AIA
Austin

CodeNEXT Charrette Report

Published by the Austin Chapter of the American Institute of Architects
July 31, 2017

Figure 4.8: All Test Sites Redevelopment Sketch

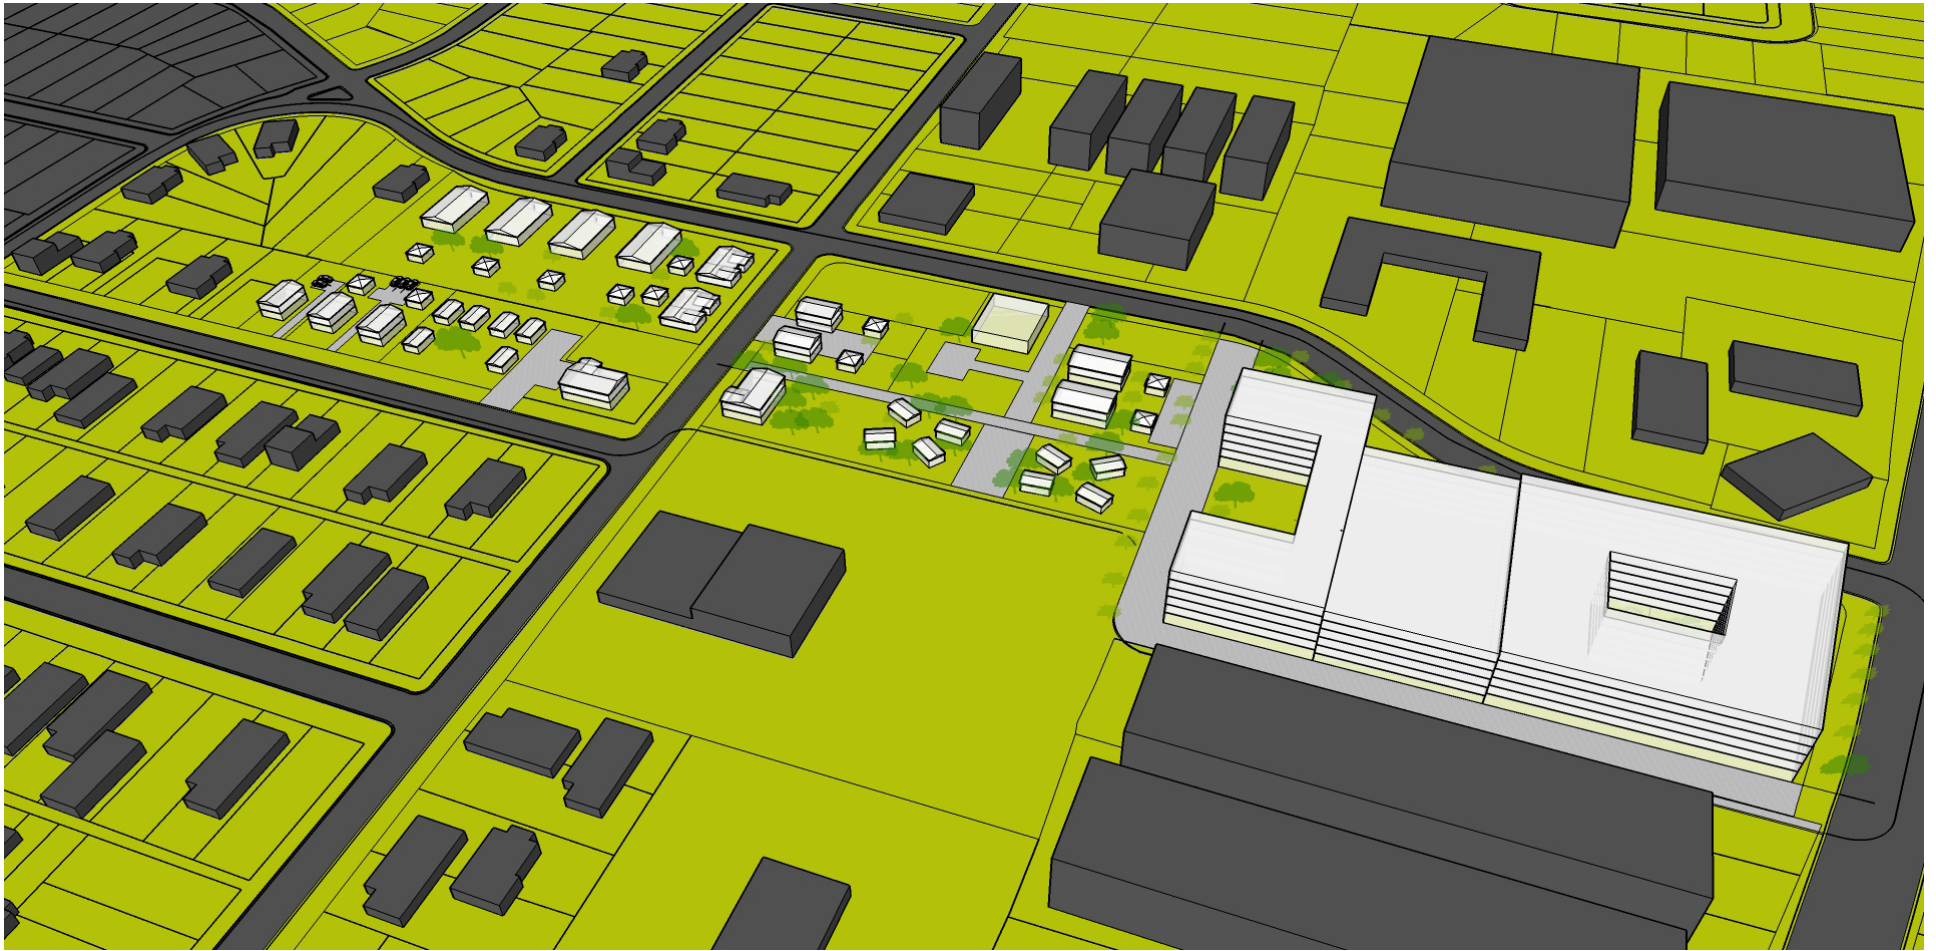
<u>Code Section</u>	<u>Sub-section</u>	<u>Recommendations</u>
23-4D-2170: T5 Urban	D: Building Types	<ul style="list-style-type: none"> Missing middle between T5 and T3 is still missing (Figure 4.8). This is partially because the draft code does not appear to be calibrated well to Austin’s varying lot sizes.
	I: Parking	<ul style="list-style-type: none"> Clarify how larger buildings in T5U can share structured parking
23-4D-2180: T5 Main Street	D: Building Types	<ul style="list-style-type: none"> T5MS on small lots is difficult to develop. Consider alternatives
23-4D-21: T4 Neighborhood Deep Setback	D: Building Types	<ul style="list-style-type: none"> Recommend less restrictive footprint size and location of ADUs. ADU’s are typically located far from the street and thus represent a “stealth” type of dwelling unit with little or no visual impact from the public view. By limiting the building envelope to 24 feet x 28 feet regardless of existing conditions, ADUs will likely become a one-size fits all approach in which home builders will build to the maximum available size and configuration every time. The Cottage Court graphic in T4N.DS conflicts with the table. The buildings are shown rotated with the wide dimension towards the street but the table says the narrow dimensions should face the street. The graphic is confusing because it shows the saddleback as a rear footprint, but the table lists it as a side footprint. The existing lot widths in Site B are 55 feet each. This limits the building types to only Small House Forms. If they had five feet more lot widths, the Medium House Forms could be utilized. This is a missed opportunity. The transects should be calibrated to the existing lot widths in the city to allow Medium House Forms in T4N.DS.

Figure 5.3: Burnet Road Redevelopment Sketch

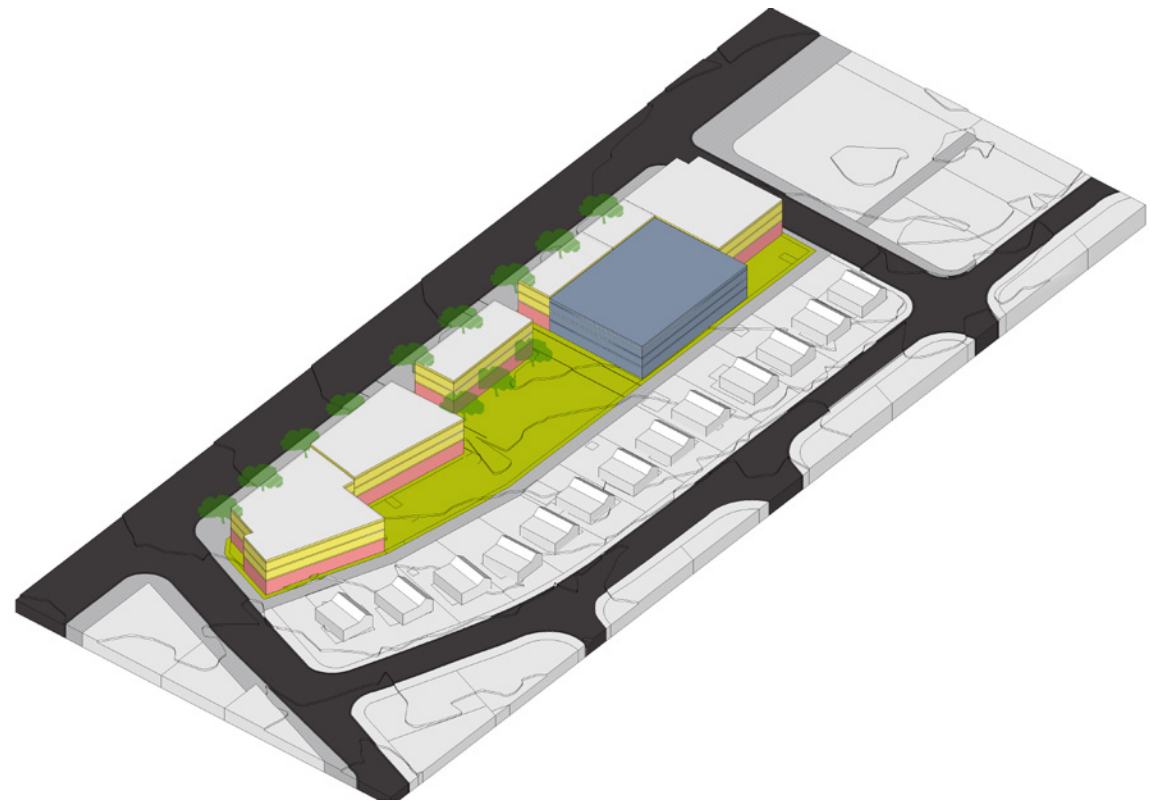
The model in Figure 5.3 shows the red commercial spaces on the ground floor with the two yellow levels of residential above. The blue volume is structured parking. While is evident that structured parking is not allowed to be inside a Main Street building it was unclear if structured parking is an allowable building type in T4MS zoning. With the high parking requirement, the team determined that there was simply not enough space for surface parking so a parking garage was used. The team assumed the full 40% parking reductions found in Section 23-4E-3060, but with the high restaurant parking requirements, the total spaces were still calculated at 194.

It was noted that T4MS zoning does not permit residential use. This was puzzling to the team as the General Intent for T4MS clearly indicates residential use. Therefore, the team proceeded as if the current permitted use language is in error. The mixed-use three story structure that was developed assumes ground floor retail and restaurant, with residential on the upper two floors. Unfortunately, the Affordable Housing Incentive Plan (AHIP) code sections were not released at the time of the Charrette, and therefore could not be tested. However, it was discovered that this site was not included in the new proposed density bonus zone even though many of the surrounding neighboring parcels are within the AHIP zone.

Figure 6.2: Test Site 6A Site Plan 1

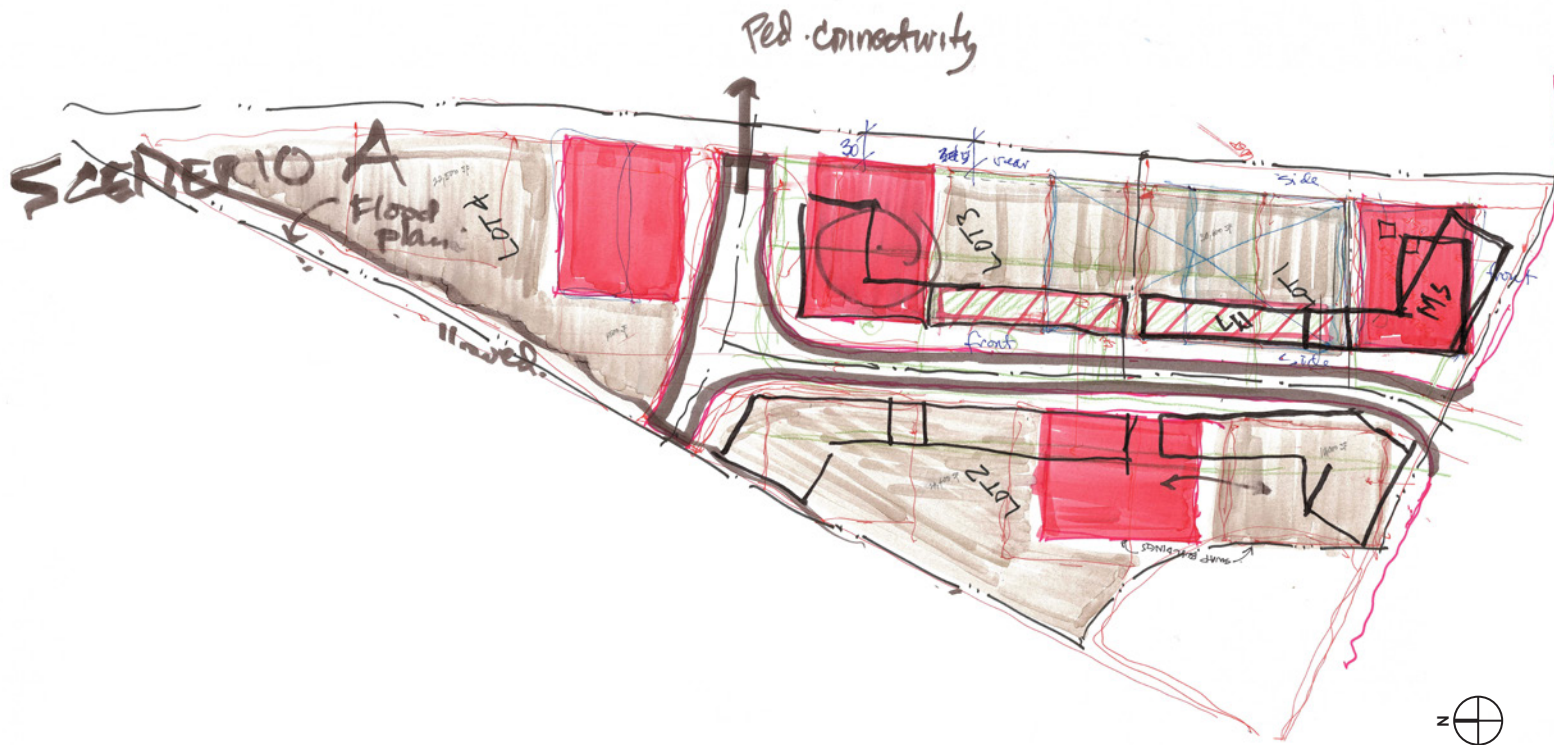
The first attempt to develop Test Site 6A was done under the most strict and literal interpretation of the code, which resulted in Design Sites that attempted to provide parking and adhere to impervious cover limits for each individual imaginary property. (Figure 6.2) Lack of detail in the building types and transect regulations led to confusion of whether structured parking was allowed, therefore this first pass included all surface parking as an illustrative exercise. The result was many small sites with inefficient buildings, dominated by surface parking lots trying to fit within the site lines and generally producing an underutilized site.

Figure 7.4: Half Block Parking Setbacks

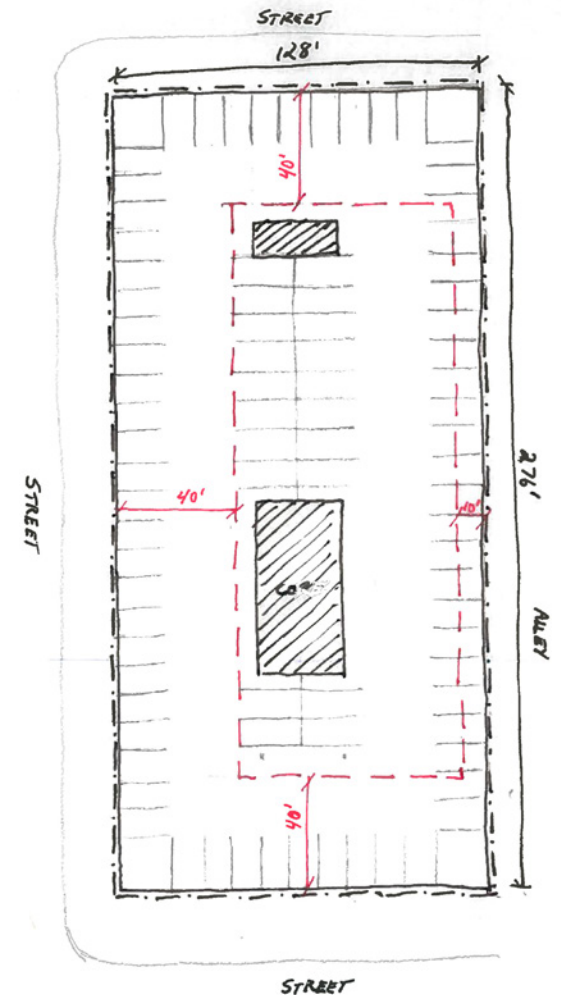
The team, trying to understand the new downtown parking requirements, and realizing the retail component was not accounted for, searched for a codified version of “shared parking” for restaurant-retail and office uses. While the code does provide this option, the requirements are burdensome and the final judgment is at the discretion of the Planning Director. The restaurant-retail component would require an entire extra level of underground parking, unnecessarily adding to the cost of development for something that would be avoided today. The team observed that the final proposed development achieved a FAR of approximately 4:1 (far short of the allowable 8:1 FAR) and would not offer an opportunity to participate in a density bonus program. Existing CVCs and the new parking requirements limited the possibility to further develop this Test Area (*Figure 7.4*).

<u>Code Section</u>	<u>Sub-section</u>	<u>Recommendations</u>
	I. Parking	<ul style="list-style-type: none"> • Eliminate parking setbacks on upper levels. This essentially forces all parking underground, which adds immense cost to the development and is not consistent with current development patterns. To create viable above-ground parking structures, this regulation will incentivize large, full-block developments. • Increase maximum allowable driveway width to allow office and residential towers to provide three standard lanes. • Remove requirement to access parking exclusively from the alley. This will cause congestion and occupies valuable frontage better suited for utilities and back-of-house services.

Figure 7.9: 8th Street Final

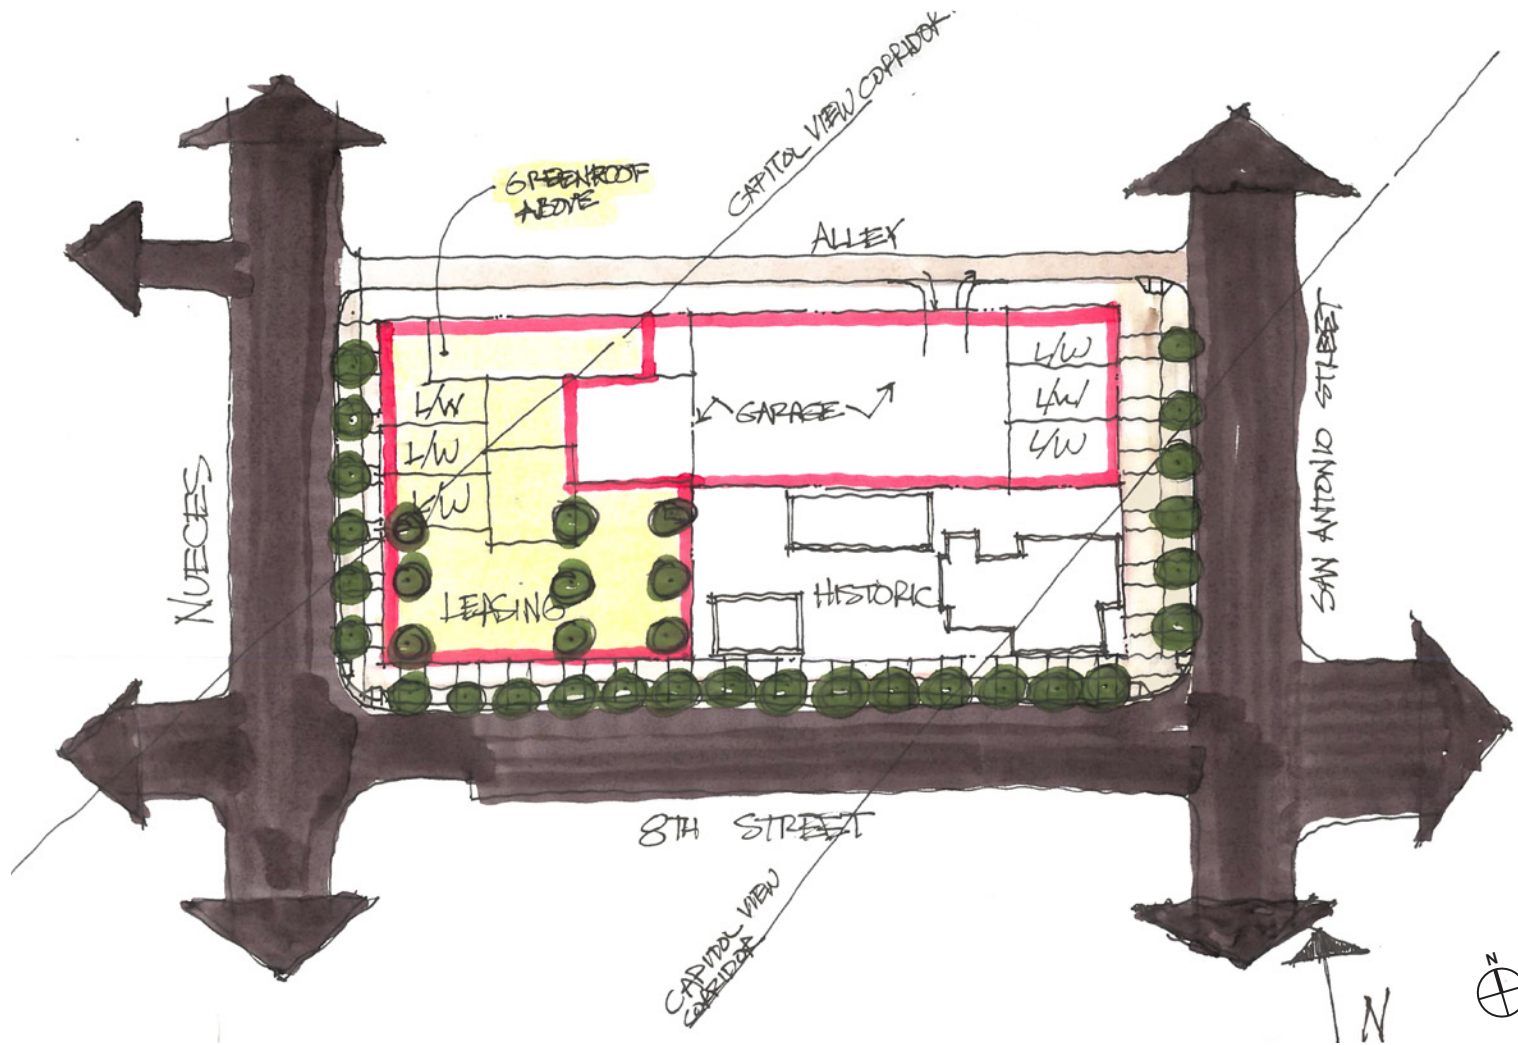
Under T6U prescriptions, the allowable height appears to be increased to 180ft or 16 stories (as compared to 120ft with DMU), but this is conditioned on participation in the density bonus program. The transect pages did not clarify allowable height by-right, so a comparison of base entitlements was impossible. If height was limited to 16 stories with participation in the density bonus program, this hypothetical T6U zoning would lead to an immediate down-zoning by six stories compared to the recently completed high-rise. The team determined that the height reduction alone could be a project-killer, reducing overall yield from 200 units to 123 units. However, further obstacles were introduced in the form of building setbacks, building envelope stepbacks at the upper levels, and parking stepbacks, which combined to eliminate any efficient floor plates and force parking underground. After sketching the double stepbacks (Figure 7.6), the resulting narrow floor plates of the first tier, floors six through eight, produced 14 residential units (assuming 85% efficiency with circulation and service cores) (Figure 7.7). The second tier, floors nine through sixteen, produced a small and inefficient floor plate, unbuildable between the cores, that it was assumed to be inviable to go above the first stepback tier (Figure 7.8). The team ignored the proposed 5ft building setback and all parking placement setbacks, envisioning two levels below-ground and two levels of above-ground parking. After considering all favorable assumptions, the Test Area yielded a total of 117 residential units under T6U zoning, which includes participation in the density bonus program; this is a 59% reduction in unit count compared to the building on the ground today (Figure 7.9).
